135 Seaforth Crescent, Seaforth

Comments on updates to Plans

GEOTECHNICAL INVESTIGATION:

New Pool and Decks at 135 Seaforth Crescent, Seaforth

SITE PLAN – showing test locations

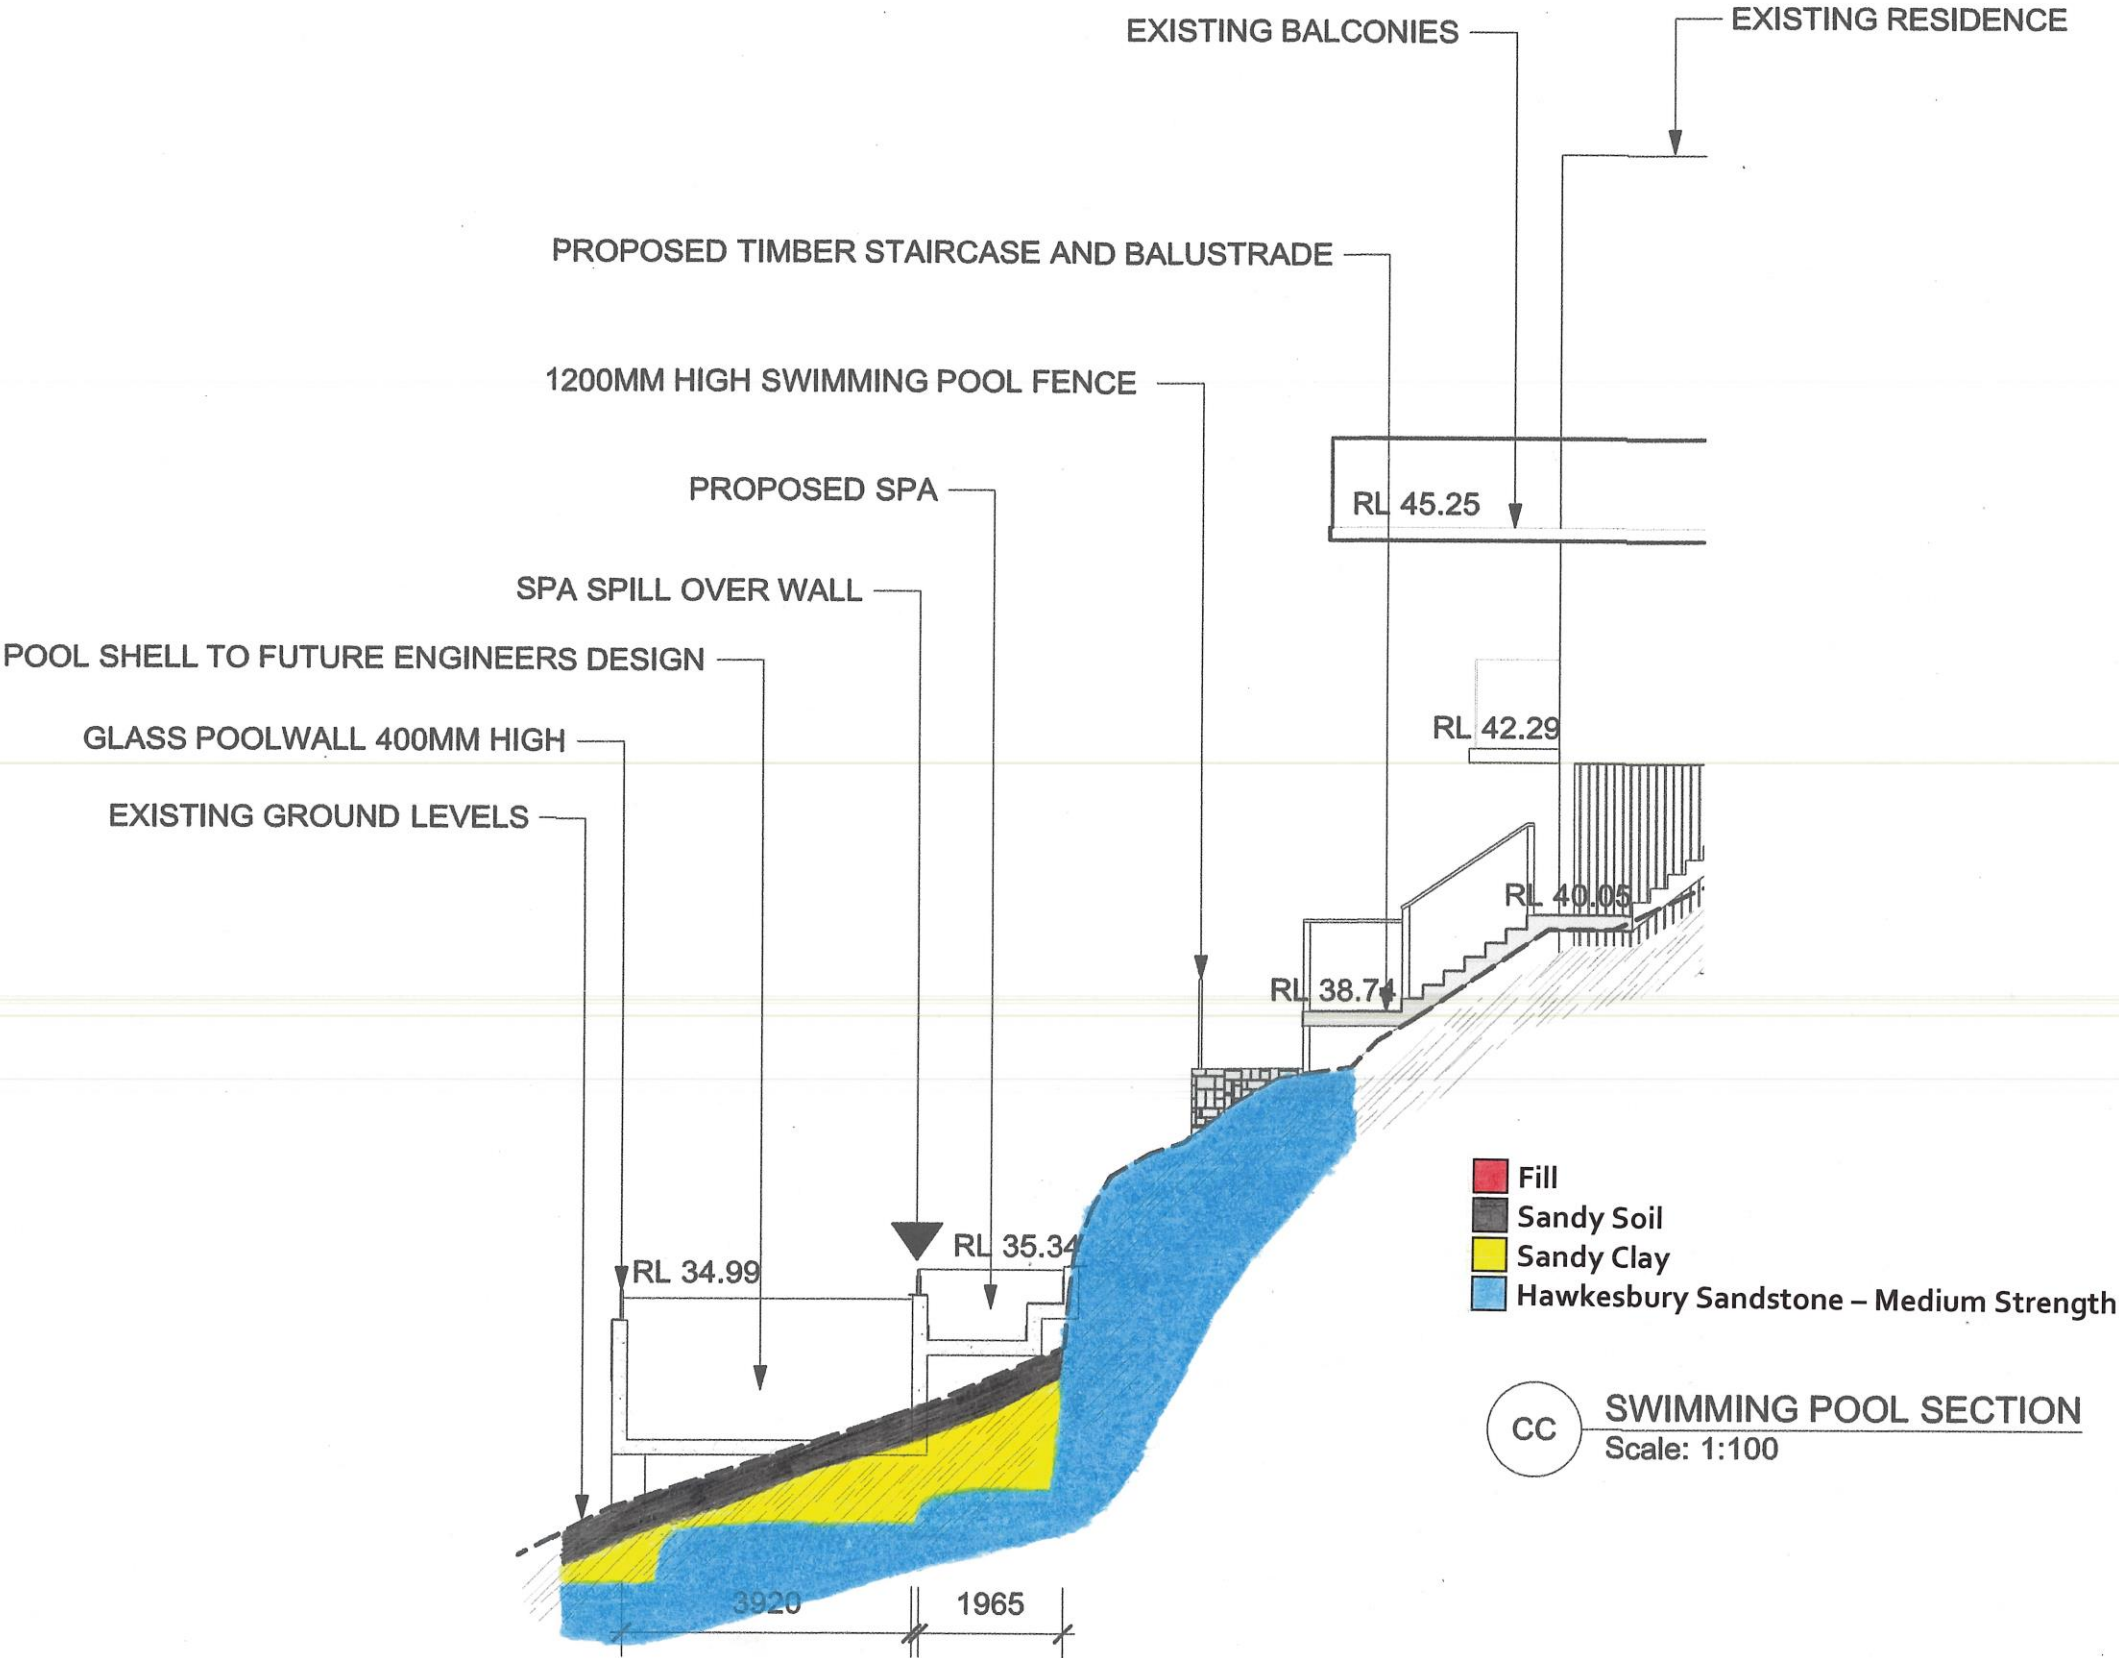
We have reviewed the existing geotechnical report, the original plans, and the 9 amended plans prepared by Urban Escape. The drawings are all numbered LA101, apart from the swimming pool plan which is not numbered. The site plan is dated 21/4/22. The other drawings are dated 27/4/22.

- Raised the pool by ~0.5m.

The changes to the plans are minor from a geotechnical perspective and do not alter the recommendations or the risk assessment in the report carried out by this firm numbered J2379A and dated the 30th September, 2020.
